Paint damage on door paneling in area of door handle

Topic number	LI72.00-P-071544
Version	1
Function group	72.00 - General
Date	11/15/24
Validity	BR 292 with code 889 BR 253 up to manufacturing data July 2020 with code 889
Reason for change

Attachments	
File	Description
Bild 1.JPG	Fault profile - rear door as example

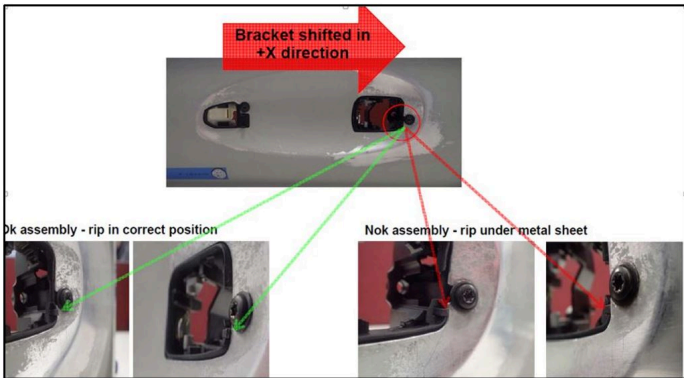
Paint damage on door paneling in area of door handle (see picture 1).

Possible tolerance complaint regarding the door handle

1. Paint the affected area of the door paneling using the spot repair procedure in accordance with the manufacturer's specifications.
2. Replace door handle, ensuring that the door handle bearing bracket is installed correctly (see picture 2).

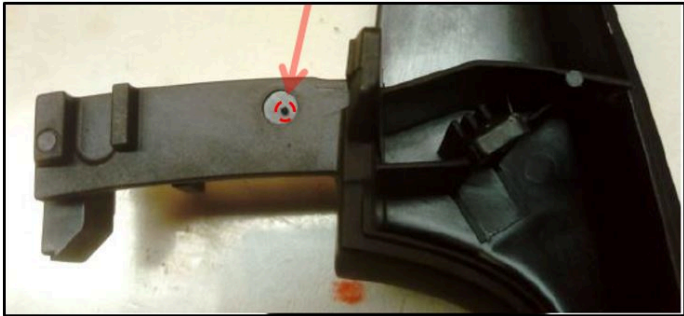
Note: The optimized door handles are marked as shown in the illustration (see picture 3).
